Request for Additional Information No. 396 (4679), Revision 1

U. S. EPR Standard Design Certification

SRP Section: 19 - Probabilistic Risk Assessment and Severe Accident Evaluation

Question 19-337:**PHASE 4 RAI****Follow-up to Open Item RAI 234, Question 19-306**

Figure 19-337-2—Revised Pressure Inputs

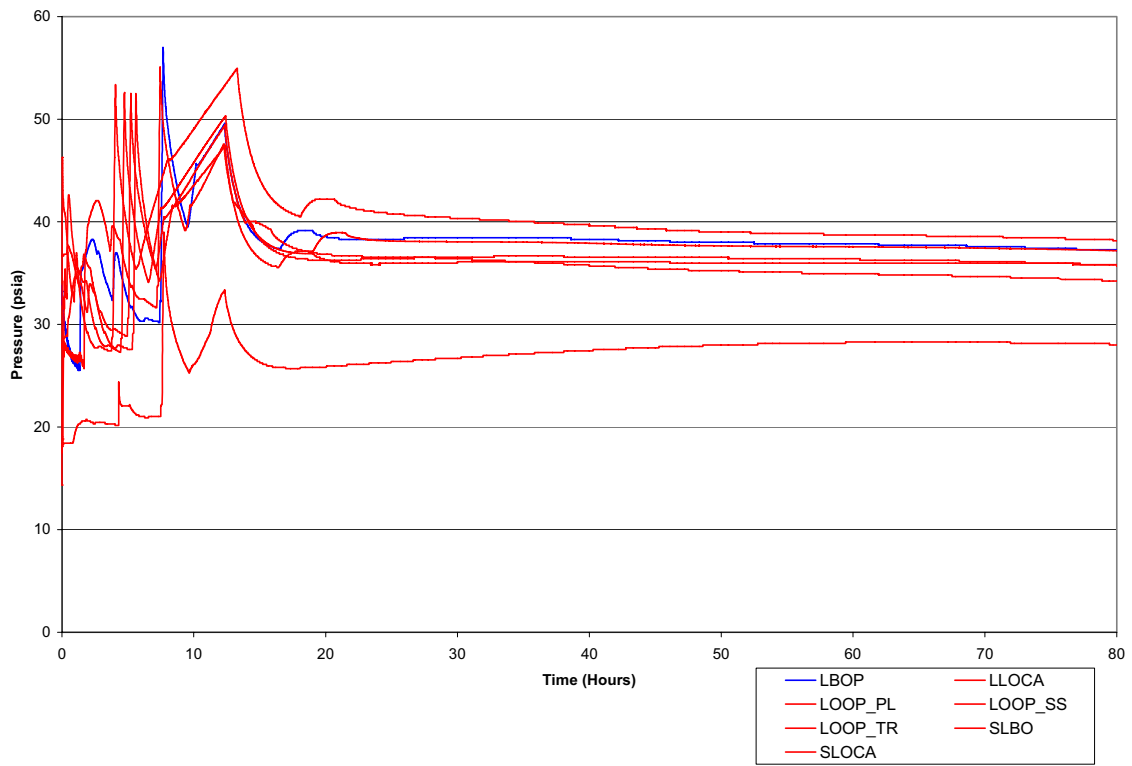
During the April 26-30, 2010, Chapter 3 audit, AREVA informed the NRC staff that Figures 19-306-1 thru 19-306-4 submitted in RAI 234, Supplement 1 response have been revised. The staff requests that these revised figures be submitted in order to complete the review of the response to the open item.

Figure 19-337-2 shows the revised pressure curves. The LBOP accident scenario (shown in blue) is has the largest peak pressure and will control. Figure 19-337-3 compares the revised and original LBOP input pressure time histories. The two time histories have the same qualitative shape, but the original time history has a higher peak pressure and is time shifted. Because temperature effects are held constant throughout the analysis and creep effects are neglected, time shifting will affect the results.
